APPLICATION NO.	FILING DATE	FIRST NAMED INVENTOR	ATTORNEY DOCKET NO.	CONFIRMATION NO.
10/809,767	03/24/2004	Sean S. Suh	001227/0125	7927

Office Action Summary	Application No. 10/809,767	Applicant(s) SUH ET AL.	
	Examiner Julianna N. Harvey	Art Unit 3733

- 1) ☒ Responsive to communication(s) filed on 27 April 2009.
- 2a) ☒ This action is **FINAL**. 2b) ☐ This action is non-final.
- 3) ☐ Since this application is in condition for allowance except for formal matters, prosecution as to the merits is closed in accordance with the practice under *Ex parte Quayle*, 1935 C.D. 11, 453 O.G. 213.

See following page for Figs. 1 and 7 of Russo et al.

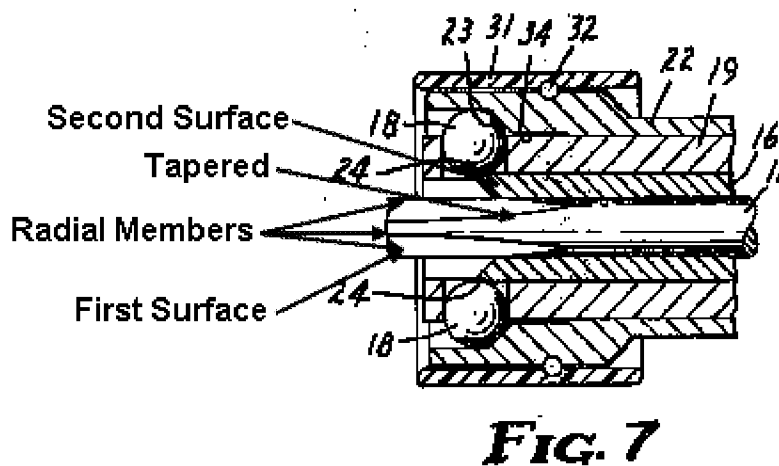
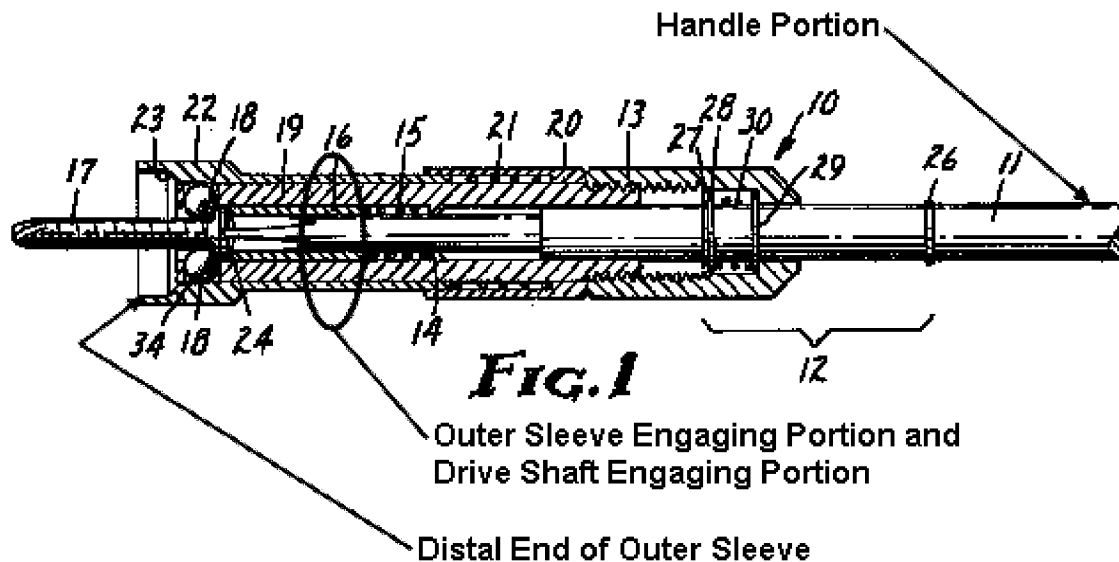
Regarding **claim 1**, Russo et al. disclose a bone fastener implantation and removal system comprising: a bone plate (35; col. 6, lines 14-17) including a top surface, a bottom surface and a plurality of fastener holes extending from the top surface to the bottom surface; a plurality of fasteners (17) receivable within the fastener holes formed in the bone plate; and a tool (10) including: a drive shaft (11, 16) having proximal and distal ends, an intermediate portion, an outer sleeve engaging portion and a length; a handle portion associated with the drive shaft proximal end; a fastener engaging portion associated with the drive shaft distal end, the fastener engaging portion comprising a first surface configured to axially engage one of the plurality of

fasteners and a second surface configured to rotationally engage the fastener; and an outer sleeve (19, 22) associated with the drive shaft intermediate portion, the sleeve comprising a proximal end, a distal end and a drive shaft engaging portion, the distal end contacting the top surface of the bone plate to apply a force to the top surface of the bone plate to facilitate removal of the fastener from the fastener holes; wherein the outer sleeve engaging portion and the drive shaft engaging portion are configured to coact to allow at least a portion of the drive shaft to translate linearly within the sleeve (Fig. 1 inset; Fig. 7 inset; Fig. 4). Regarding **claim 2**, Russo et al. disclose that the drive shaft (11, 16) comprises a cannulated fastener driving portion (16) and an inner shaft portion (11), at least a portion of the inner shaft portion being slidably disposed within the fastener engaging portion, the inner shaft portion being configured to axially engage the fastener while the fastener driving portion is configured to rotationally engage the fastener (Fig. 1). Regarding **claim 6**, Russo et al. disclose that the inner shaft portion (11) is tapered and the cannulated fastener driving portion (16) is configured to slidably receive the tapered inner shaft (Fig. 7 inset). Regarding **claim 8**, Russo et al. disclose that the first surface comprises at least one radial member configured to axially engage a recess in a head of the fastener (17) (Fig. 7 inset). Regarding **claim 9**, Russo et al. disclose that the first surface comprises a plurality of radial members, each of which is configured to axially engage corresponding recesses in the fastener head (Fig. 7 inset). Regarding **claim 12**, Russo et al. disclose an inner shaft (11) having a fastener engaging surface ("First Surface") at one end, the drive shaft further comprising a cannulation (16 is cannulated) configured and sized to accept at least a portion of the

inner shaft, wherein when the inner shaft is disposed within the cannulation the fastener engaging surface extends distally beyond the distal end of the drive shaft (Fig. 7 inset).

Regarding **claim 43**, Russo et al. disclose a bone fastener implantation and removal system comprising: a bone plate (35; col. 6, lines 14-17) including a top surface, a bottom surface and a plurality of fastener holes extending from the top surface to the bottom surface; a plurality of bone fasteners (17) receivable within the fastener holes formed in the bone plate; and a tool (10) including: an inner shaft (11) for engaging one of the bone fasteners, an outer shaft (16) for engaging the bone fastener, and an outer sleeve (19, 22) for contacting the top surface of the bone plate and applying a force to the top surface of the bone plate to facilitate removal of one of the plurality of fasteners from the fastener holes; wherein the inner shaft is configured to axially engage the bone fastener and is slidably disposed within the outer shaft; wherein the outer shaft is configured to rotationally engage the bone fastener and further comprises an outer sleeve engaging portion; and wherein the outer sleeve further comprises an outer shaft engaging portion ("Drive Shaft Engaging Portion") such that the shaft may translate linearly within the outer sleeve when the outer sleeve engaging portion rotationally engages the outer shaft engaging portion (Fig. 1 inset).

Regarding **claim 14**, Russo et al. disclose that the fastener engaging portion further comprises a locking clip expanding portion ("Second Surface"), that the fastener (17) is disposed within the fastener holes formed in the plate (35), and that the locking clip expanding portion is configured to expand the locking clip (Fig. 7 inset; Fig. 4).

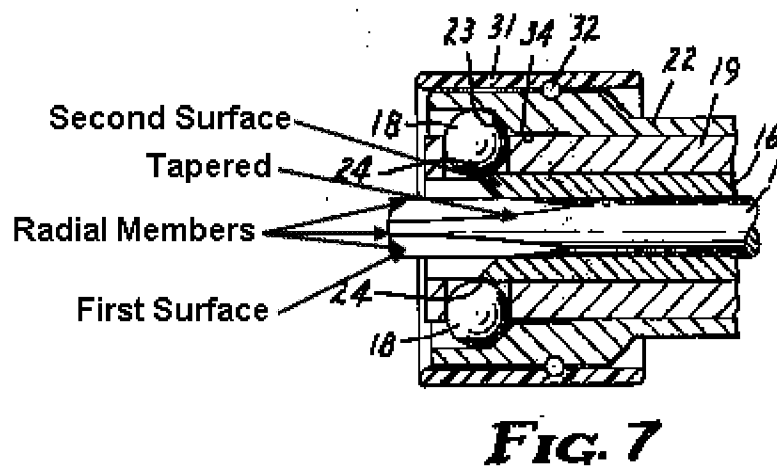
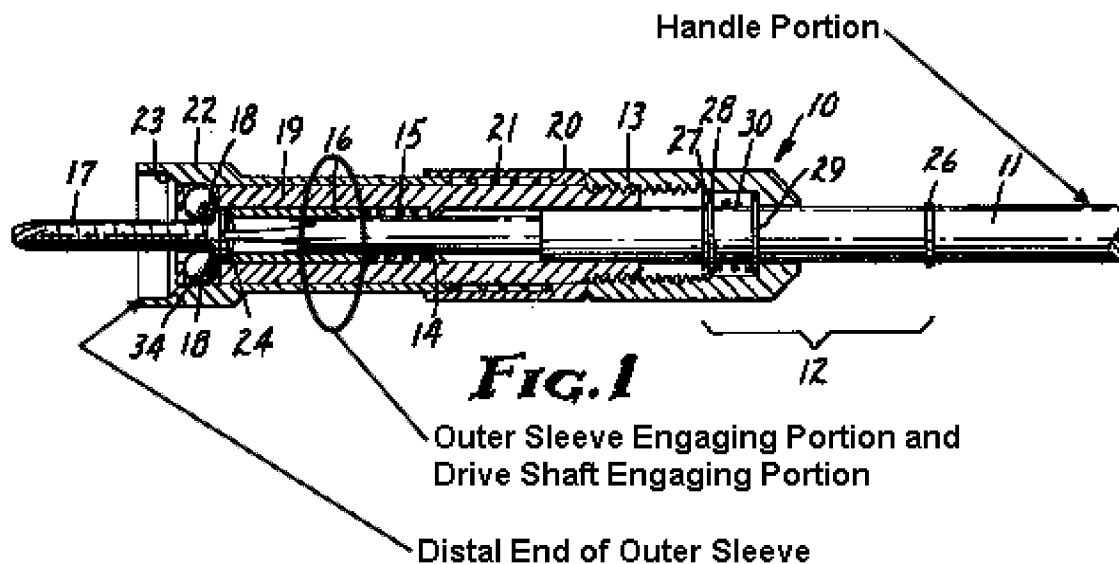
Claims 25-27 are rejected under 35 U.S.C. 103(a) as being unpatentable over Russo et al. (US 4,140,161 A) in view of Bryant et al. (US 5,649,931 A). Regarding **claim 25**, Russo et al. disclose a bone fastener implantation and removal system comprising: a bone plate (35; col. 6, lines 14-17) including a top surface, a bottom surface and a plurality of fastener holes extending from the top surface to the bottom surface; a plurality of fasteners (17) receivable within the fastener holes formed in the bone plate; and a tool (10) including: a drive shaft (11, 16) having a fastener engaging end and a sleeve engaging portion ("Outer Sleeve Engaging Portion"), the fastener engaging end comprising a rotational engagement portion ("Second Surface") and an axial engagement portion ("First Surface"); a sleeve (19, 22) disposed about at least a portion of the drive shaft, the sleeve comprising a proximal end, a distal end and a drive

shaft engaging portion, the distal end contacting the top surface of the bone plate to apply a force to the top surface of the bone plate to facilitate removal of one of the plurality of fasteners from the fastener holes; wherein the drive shaft can translate linearly within the sleeve when the drive shaft is rotated relative to the sleeve (Fig. 1 inset; Fig. 7 inset; Fig. 4). Regarding **claim 26**, Russo et al. disclose that the drive shaft (11, 16) comprises a cannulated fastener driving portion (16) and an inner shaft portion (11), at least a portion of the inner shaft being slidably disposed within the driving portion, the inner shaft portion being configured to axially engage one of the fasteners while the driving portion is configured to rotationally engage the fastener (Fig. 1; Fig. 7 inset). Regarding **claim 27**, Russo et al. disclose that the inner shaft portion (11) is tapered and the cannulated fastener driving portion (16) is configured to slidably receive the tapered inner shaft (Fig. 7 inset). Russo et al. fail to disclose that the sleeve engaging portion and the drive shaft engaging portion comprise complementary threads (**claim 25**). Bryant et al. teach a bone fastener implantation and removal tool comprising: a drive shaft (14, 16) having a sleeve engaging portion (38) and a sleeve (18) having a shaft engaging portion (36) wherein the sleeve engaging portion and shaft engaging portions comprise complementary threads (Figs. 4-5; col. 3, lines 17-19). It would have been obvious to one of ordinary skill in the art at the time the invention was made to modify Russo et al. such that the sleeve engaging portion and shaft engaging portions comprise complementary thread (**claims 25**), as suggested by Bryant et al., as doing so is merely a combination of prior art elements according to known methods to yield predictable results.

drive shaft (11, 16) is configured to engage one of the plurality of fasteners (17) disposed within one of the plurality of fastener holes formed in the plate (35), and that the fastener engaging end is configured to expand the fastener locking clip when the drive shaft engages the fastener (Fig. 7 inset above; Fig. 4). Regarding **claim 29**, Russo et al. disclose that the locking clip expanding portion is configured to expand the locking clip to a dimension greater than an outer dimension of the fastener head. Regarding **claim 30**, Russo et al. disclose that the locking clip expanding portion is configured to expand the locking clip to a dimension smaller than an outer diameter of the fastener head. Russo et al. and Bryant et al. fail to teach that the plate has an expandable locking clip disposed within the fastener hole, the clip configured to engage a portion of the fastener to prevent the fastener from backing out of the fastener hole (**claim 28**), and that when the tool is engaged with the fastener and the tool is operated to remove the fastener from the bone plate, an axial removal force applied by the tool is greater than a fastener locking force of the locking clip (**claim 31**). Bailey et al. teach a bone plate (12) and a plurality of fasteners (14) disposed within fastener holes in the plate (Fig. 4). Bailey et al. also teach a locking clip (16) disposed within each of the fastener holes to prevent the fasteners from backing out of the plate (Fig. 4; para. 0032). Bailey et al. also teach a tool (90) configured to remove the fastener from the plate (Fig. 10). As such, the axial removal force applied by the tool must be greater than the fastener locking force of the clip in order to successfully remove the fastener. It would have been obvious to one of ordinary skill in the art at the time the invention was made to provide the Russo et al. plate with locking clips that engage the fasteners when
